**ALTA EAST WIND PROJECT
PROPOSED
PLAN AMENDMENT AND FINAL
ENVIRONMENTAL IMPACT STATEMENT**

Volume 2B
Chapters 7 through Appendix A

February 2013
CACA #0052537

7. Response to Comments on the Draft EIS/EIR

**Figure 2-6
Proposed GPA's**

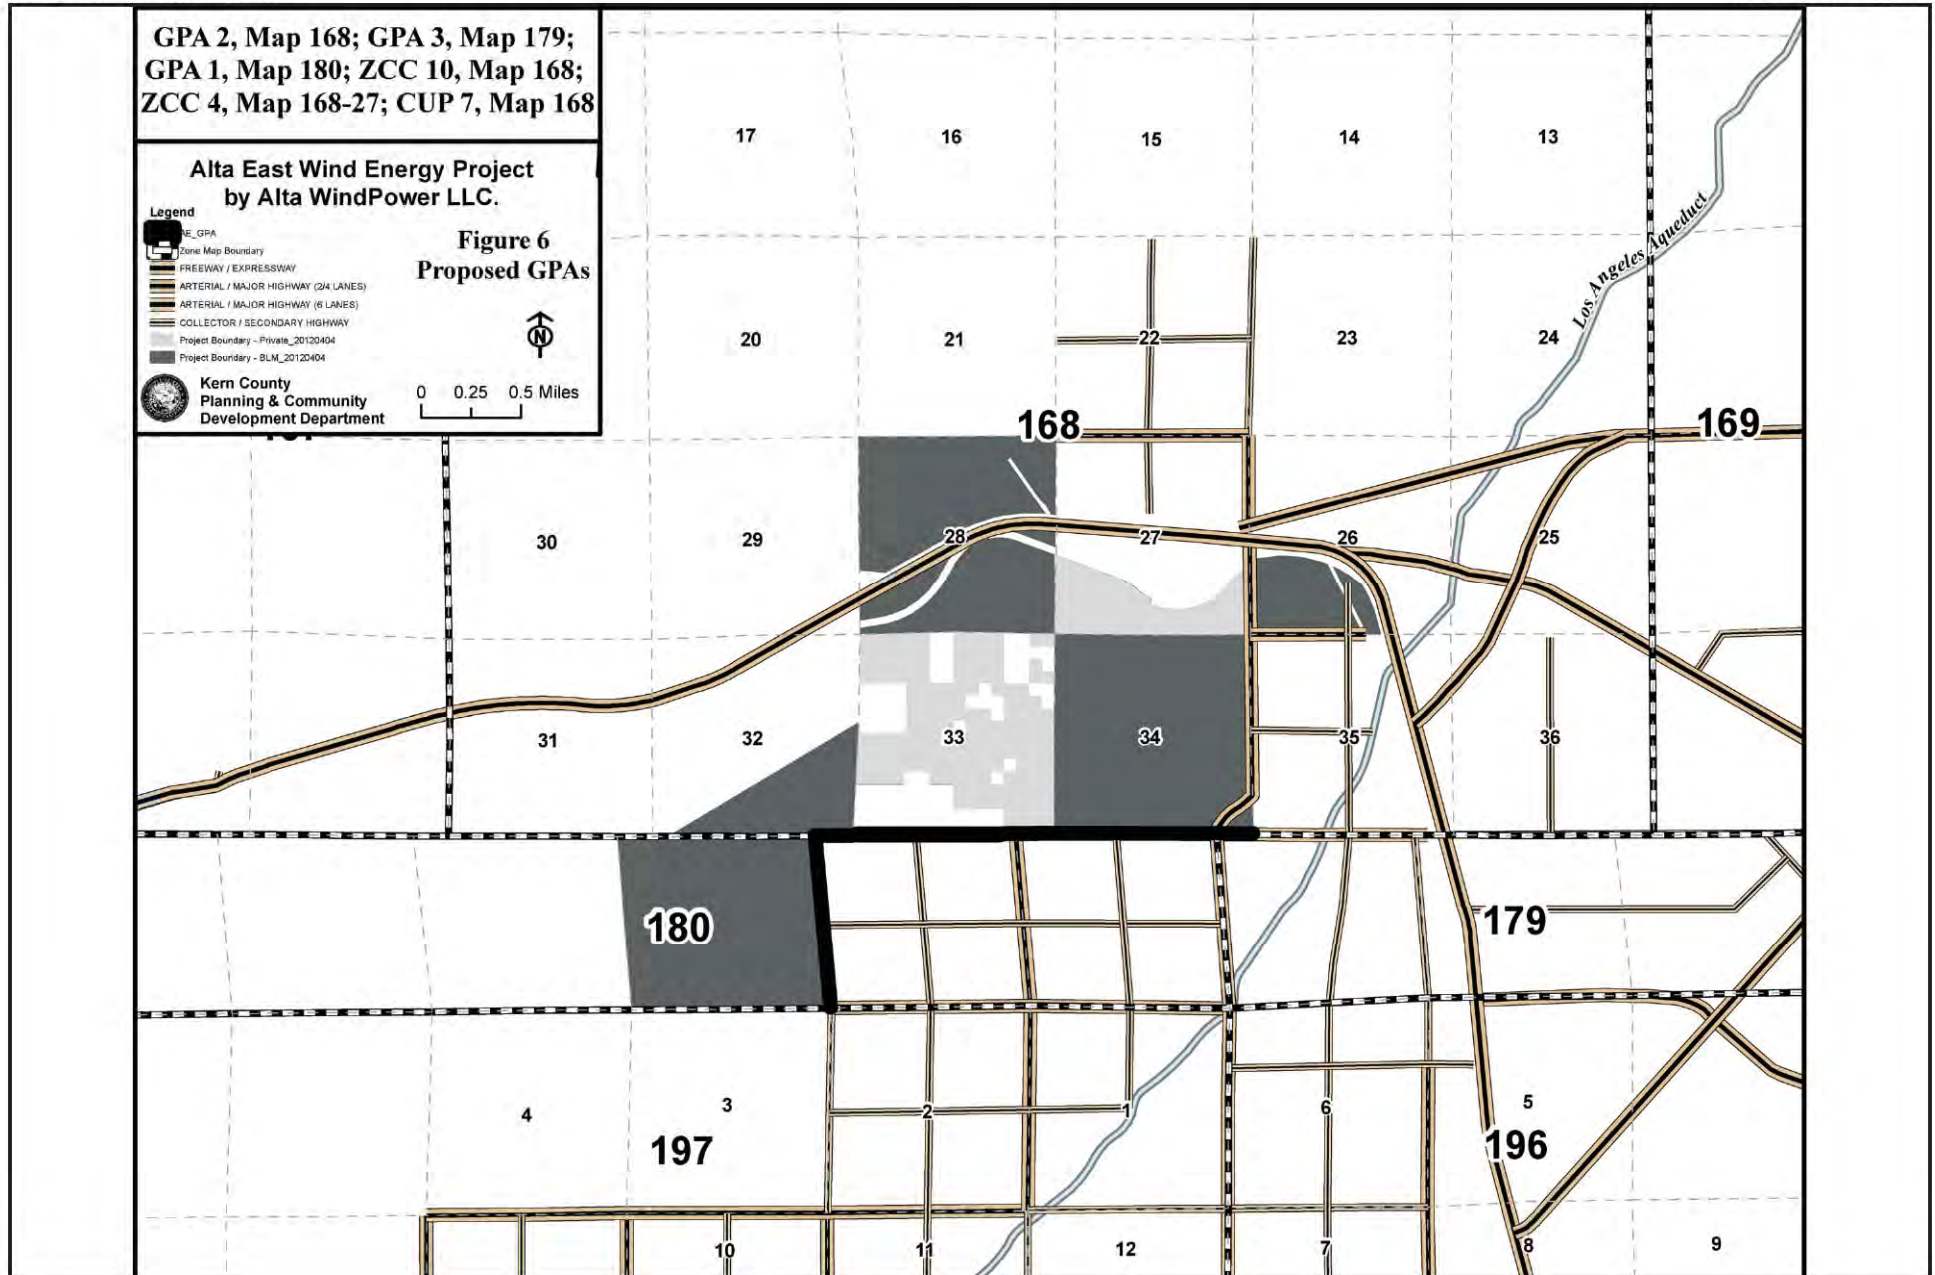
Appendix A, Page A-6 Figure 2-6, Proposed GPAs

Figure 2-6, *Proposed GPAs*, was included in the DEIS/EIR to illustrate proposed amendments to the Circulation Element of the Kern County General Plan to eliminate future road reservations along section lines within the project boundary. The Circulation Element currently designates section and mid-section lines located in certain areas of eastern-Kern as reserved for future build-out of arterial and collector type roads. This designation is for land use planning purposes only and does not actually denote the locations of any existing physical roads or public easements. Removal of portions of these designations simply means that those areas would no longer be intended for future arterial and collector sized roads. Amendment of the Circulation Element does not remove any existing roads or eliminate any existing legal access to any parcel.

Upon further review of Figure 2-6, the BLM and Kern County have determined that minor adjustments to the areas shown for removal are necessary. The figure shown in the Draft EIS/EIR reflects removal of some partial portions of section lines; however, the BLM and Kern County have determined that it would be more appropriate to remove complete section lines to ensure cohesive land use planning because there is no need to retain partial reservations when there are no contiguous reservations remaining. An example of this is shown in Section 33, 32.S. 35.E., which previously illustrated removal of only portions of the south section line, thereby leaving pieces of the section line as reserved without a contiguous reservation. The revised figure reflects removal of the complete south section line. Amendments to this figure are shown on the attached revised Figure 2-6 and do not affect any existing roads and do not change the impacts of the project; therefore, no further revisions are warranted.
